[Docket No. FAA-2013-0146; Directorate Identifier 2012-SW-060-AD; Amendment 39-17559; AD 2013-16-21]

Airworthiness Directives; Agusta S.p.A. (Type Certificate Currently Held by Agusta Westland S.p.A) (Agusta) Helicopters

ACTION: Final rule.

Figure 1 to Paragraph (f)(1), T/R Blade, P/N 109-8132-01-111

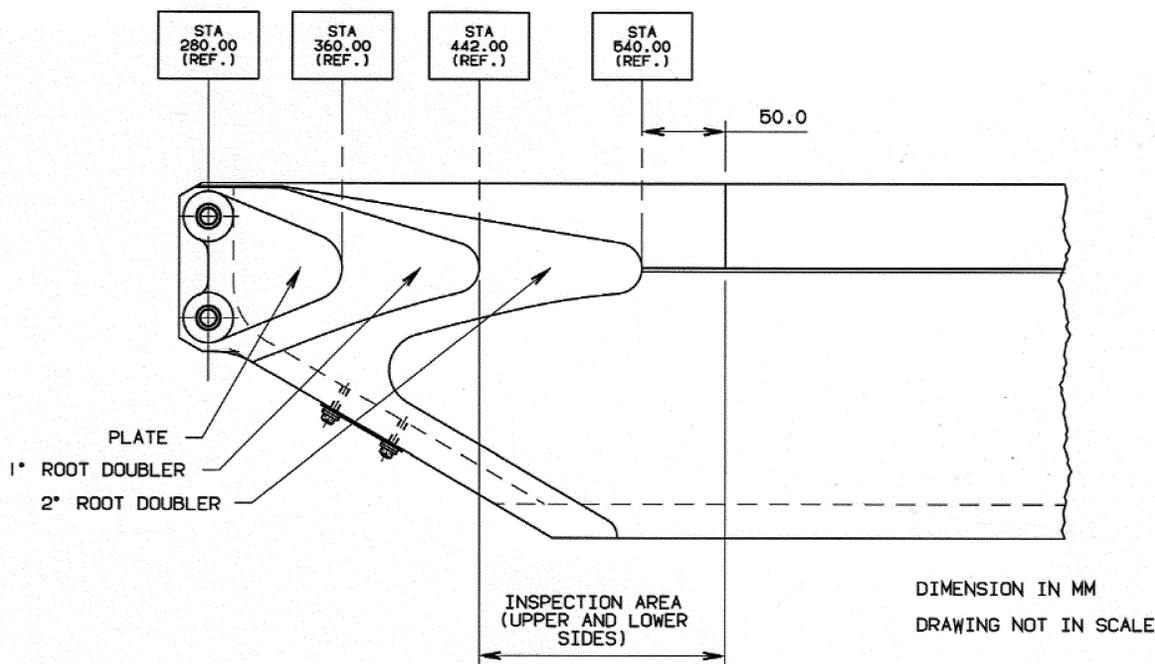
(1) Before each start of the helicopter engines, visually check both sides of each T/R blade for a crack in the inspection area depicted in Figure 1 to paragraph (f)(1) of this AD. This action may be performed by the owner/operator (pilot) holding at least a private pilot certificate, and must be entered into the aircraft records showing compliance with this AD in accordance with 14 CFR 43.9 (a)(1)-(4) and 14 CFR 91.417(a)(2)(v). The record must be maintained as required by 14 CFR 91.417, 121.380, or 135.439.
